# [ETASR] Revisions Required (#7574)

"Modeling and Predicting Steam Power Plant Condenser Vacuum based on Small-sized Operation Data" (#7574).

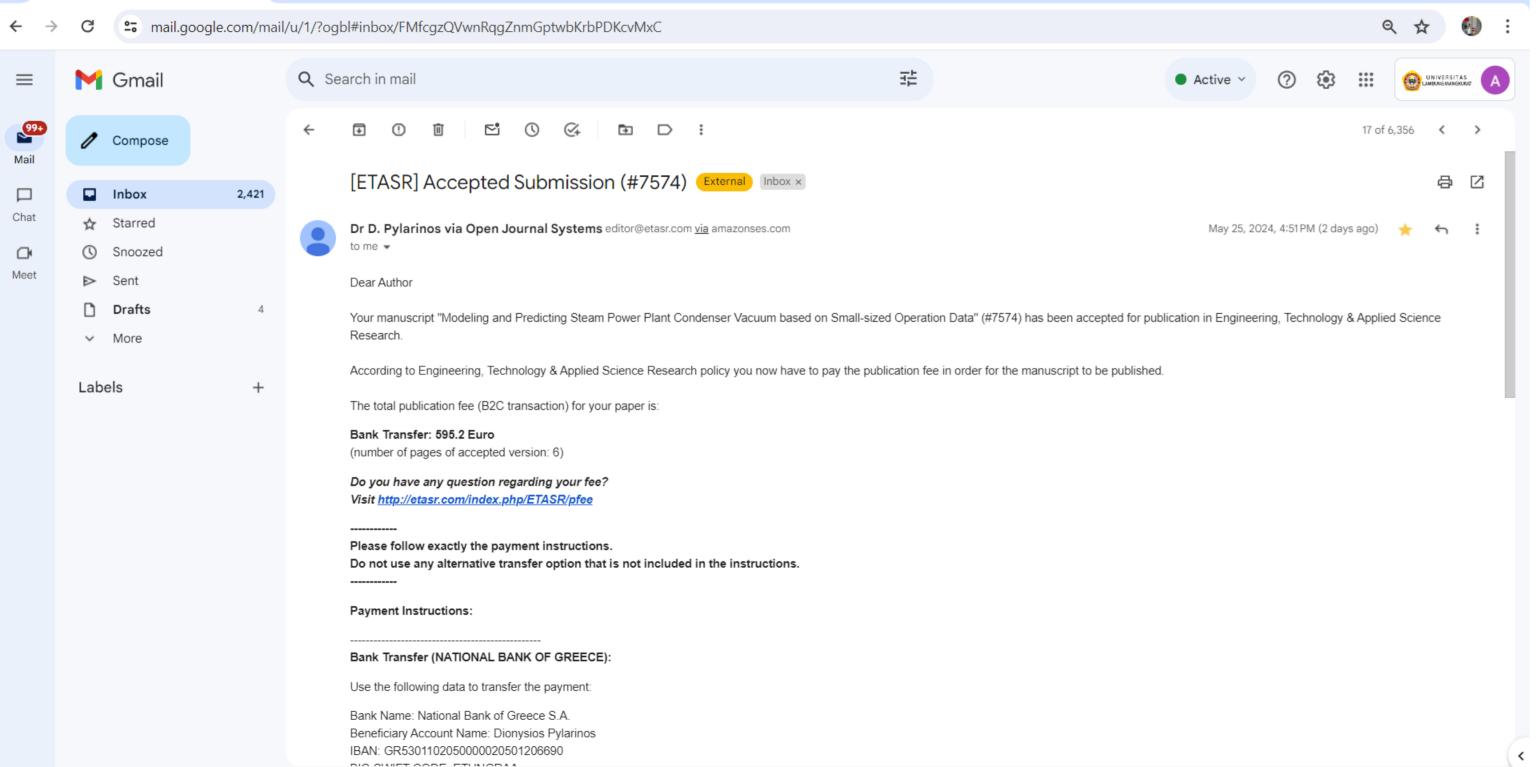
Please indicate the source of the dataset in Table 1.
